APPEAL SUMMARY

Appeal ID: 23511	Project Address: 2400 NE Broadway St
Hearing Date: 2/26/20	Appellant Name: Joshua Klyber
Case No.: B-018	Appellant Phone: 5032091458
Appeal Type: Building	Plans Examiner/Inspector: Chanel Horn
Project Type: commercial	Stories: 1 Occupancy: A-2, F-2 Construction Type: V-B
Building/Business Name: Broadway Brewery	Fire Sprinklers: Yes - Throughout
Appeal Involves: Alteration of an existing structure, Reconsideration of appeal	LUR or Permit Application No.: 19-248077-LU
Plan Submitted Option: pdf [File 1] [File 2] [File 3] [File 4] [File 5] [File 6]	Proposed use: Brewery

NE BROADWAY BREWERY

2400 NE BROADWAY ST.
PORTLAND, OR 97232

PROPOSED SITE PLAN

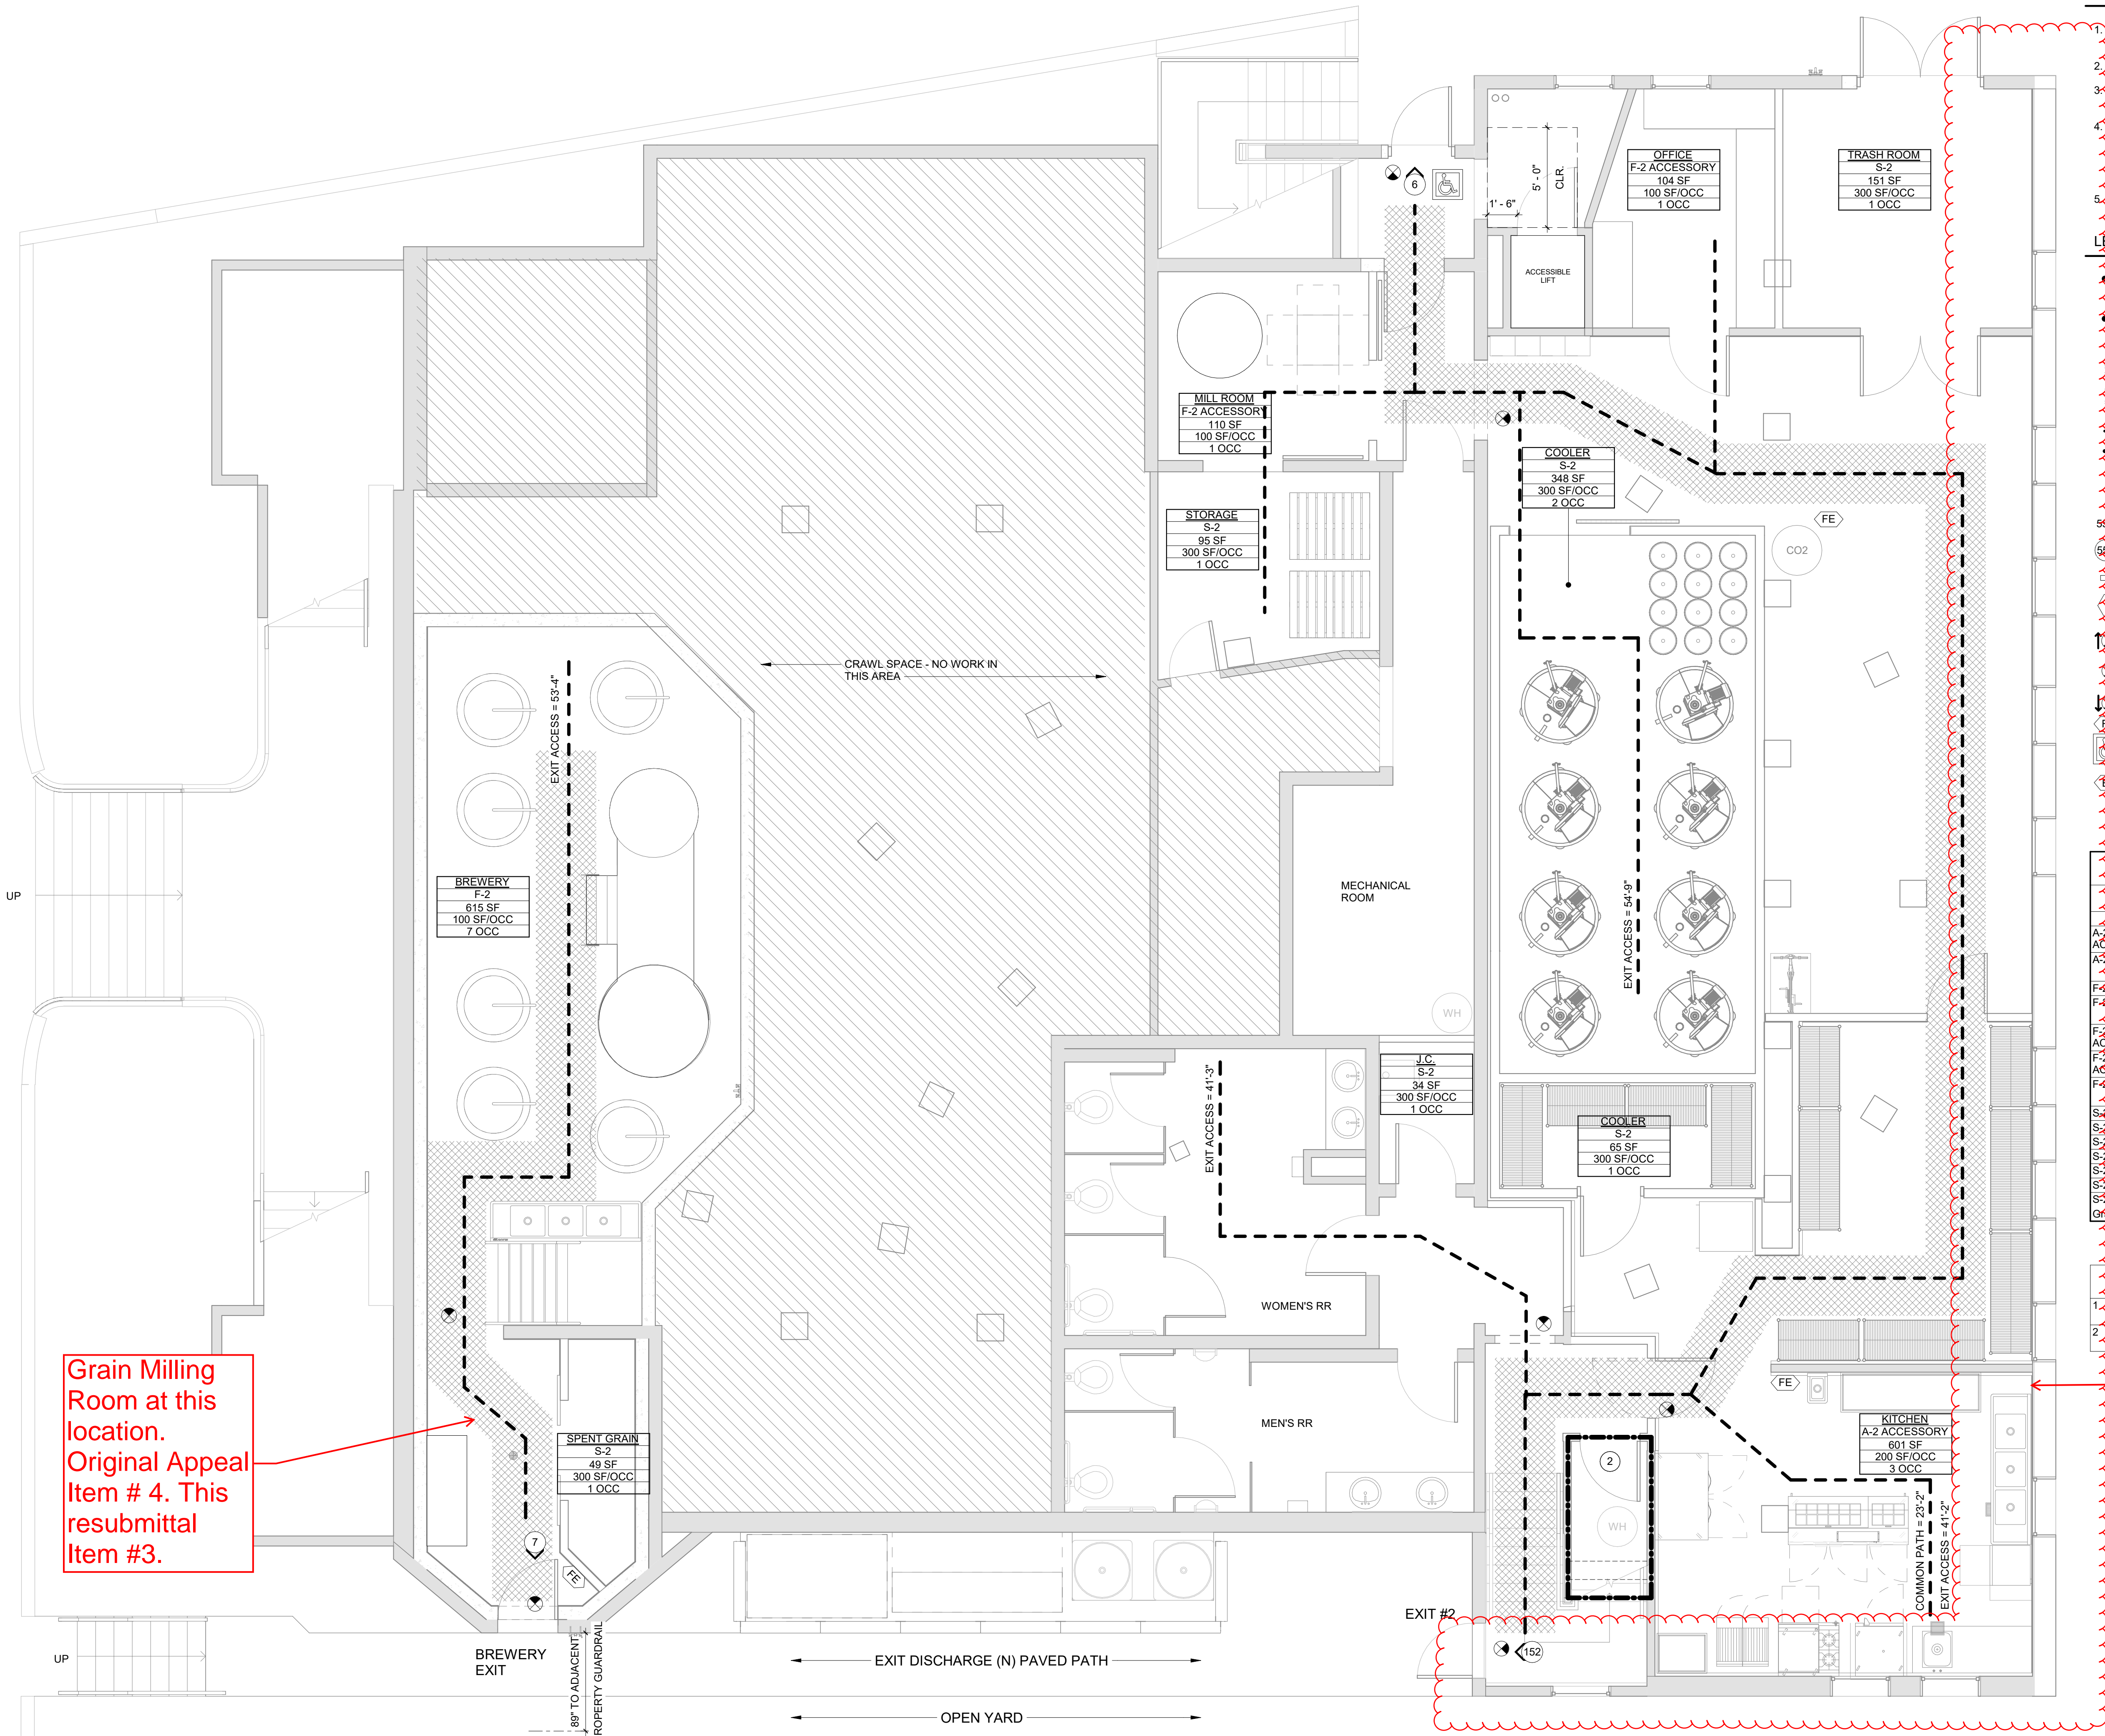
Windows at this location will be sprinklered. Approved per Original appeal Item #3

Windows along these exterior walls will be sprinklered. Item # 2.

- 1. Use of ship's ladder to access brewery tanks: Granted as proposed.**
- 2. Type 13 water curtain sprinkler protection at non-fire rated openings in exterior walls where openings are not allowed: Granted as proposed.**
- 3. Exemption from high hazard occupancy classification for grist milling system: Denied. Proposal does not provide equivalent Life Safety protection.**

BASEMENT - CODE PLAN

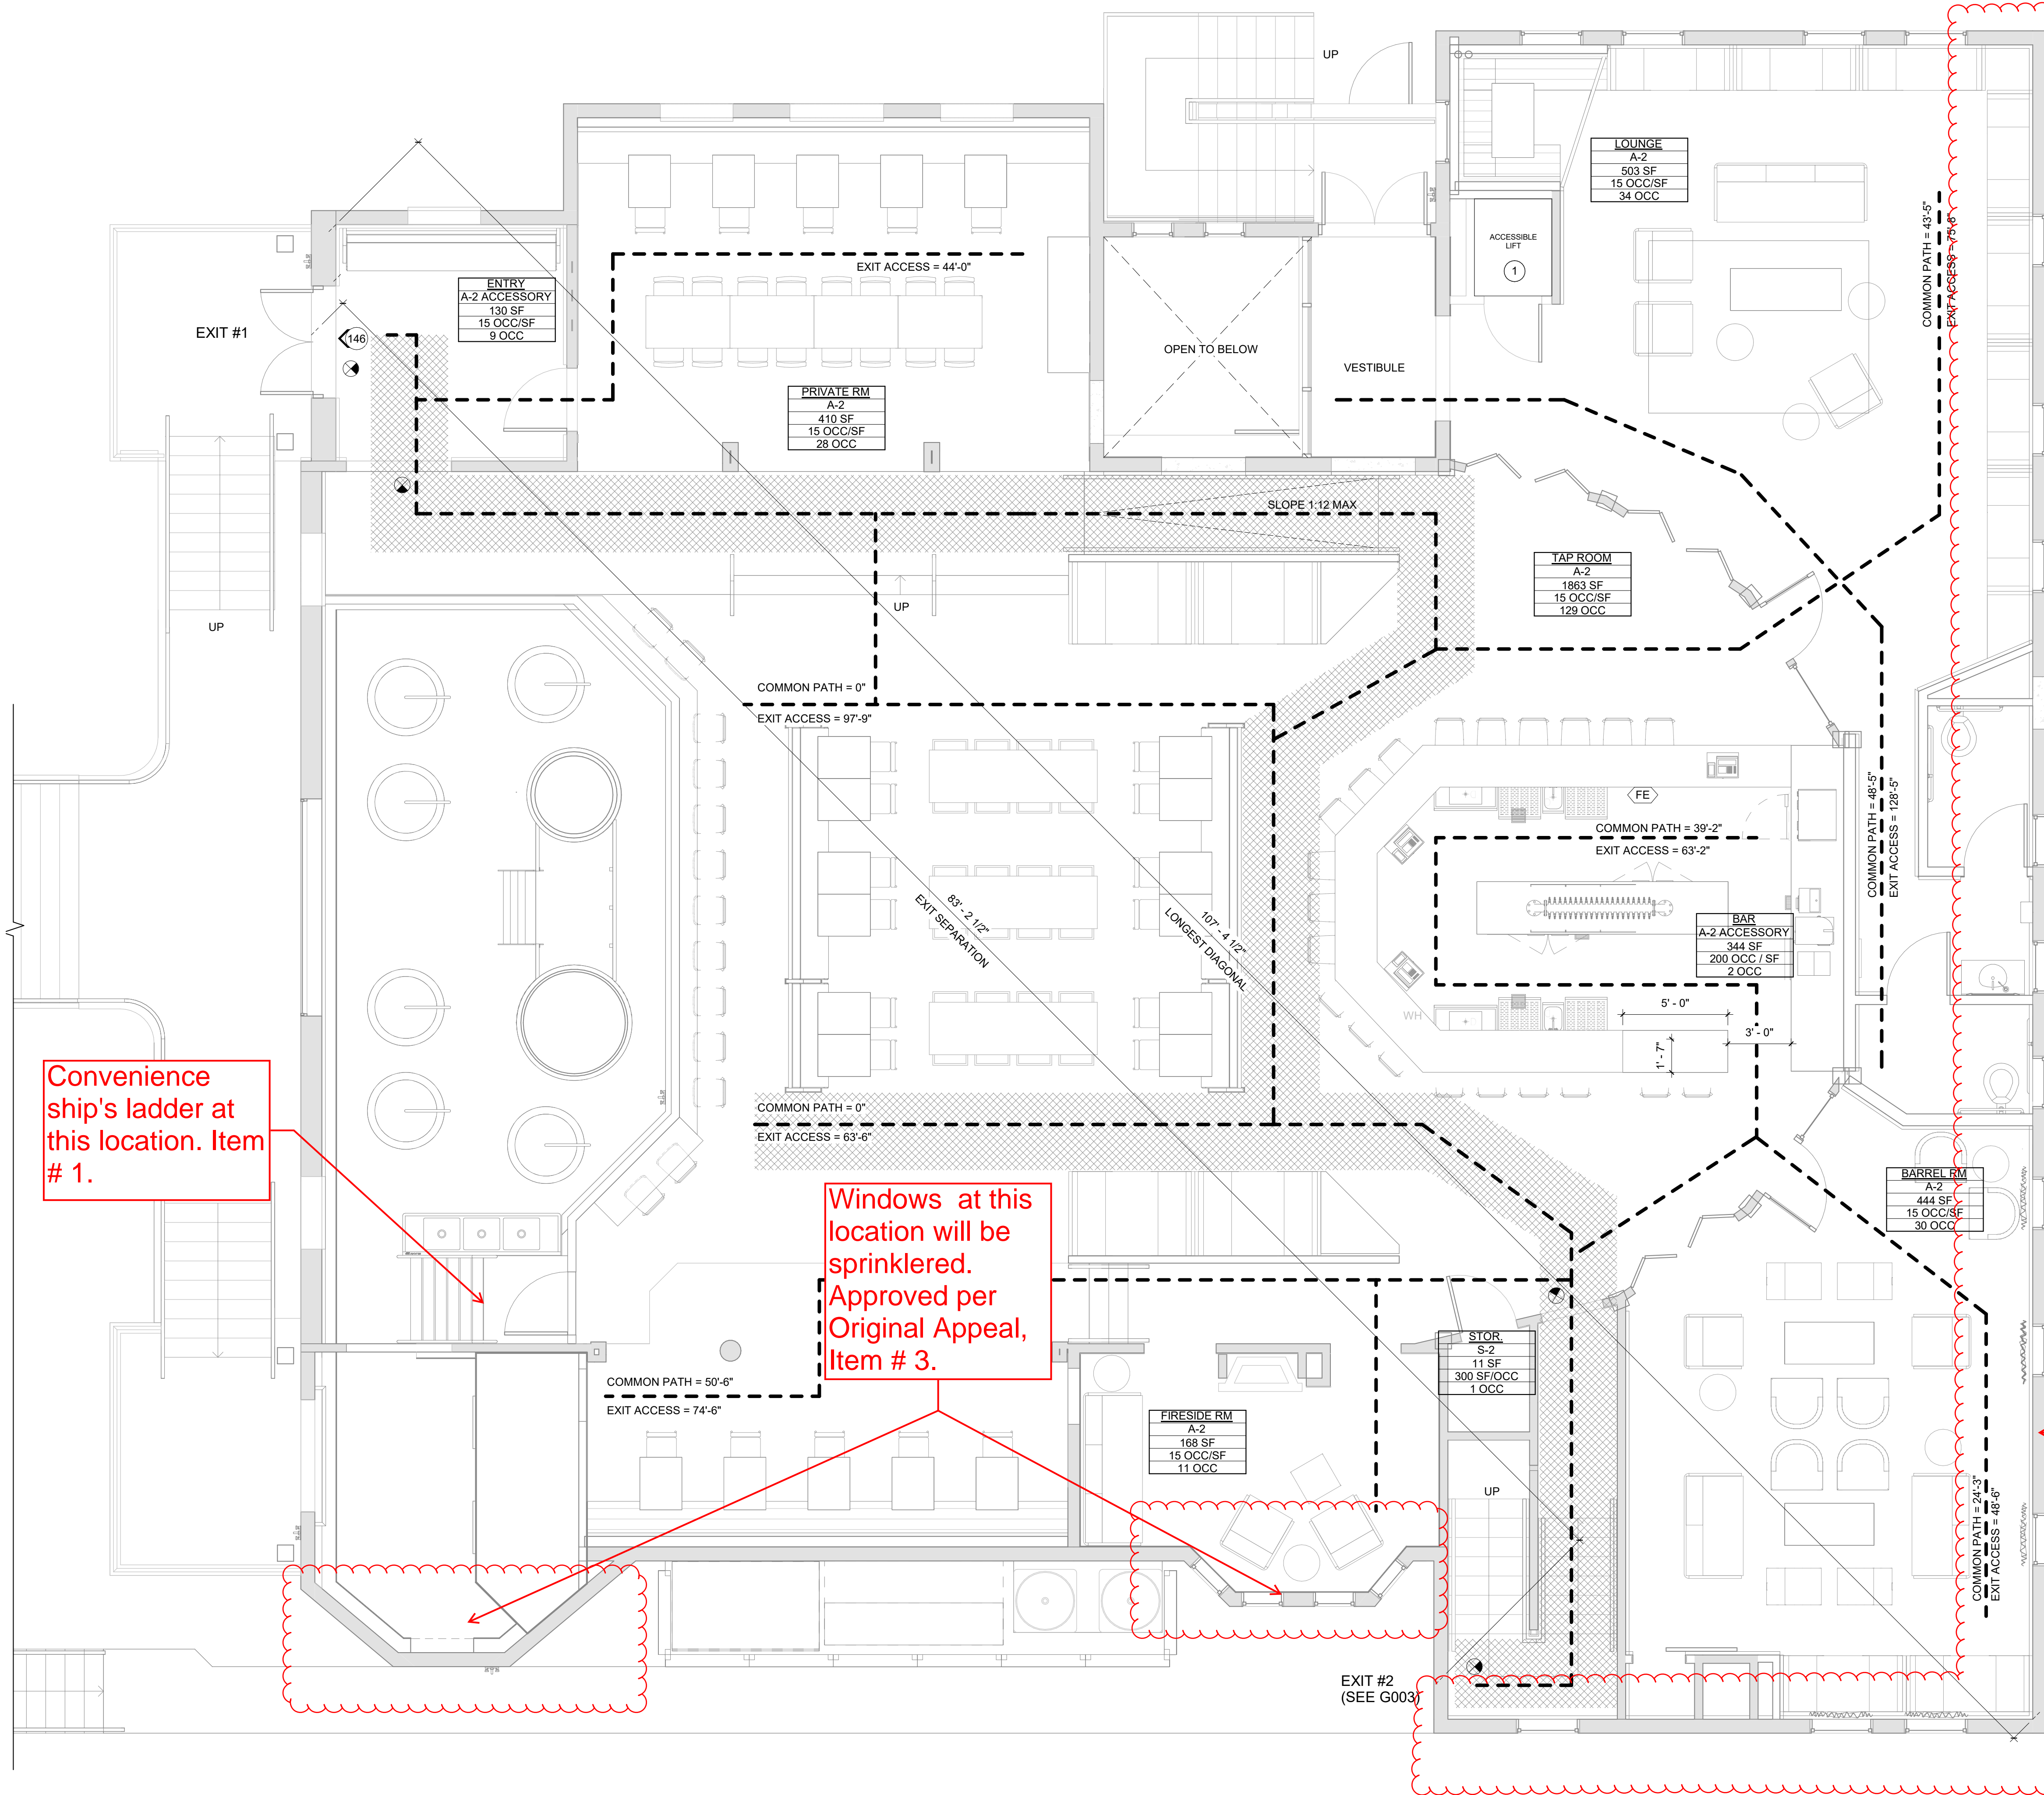
Windows along these exterior walls will be sprinklered. Item # 2.

Grain Milling Room at this location. Original Appeal Item # 4. This resubmittal Item #3.
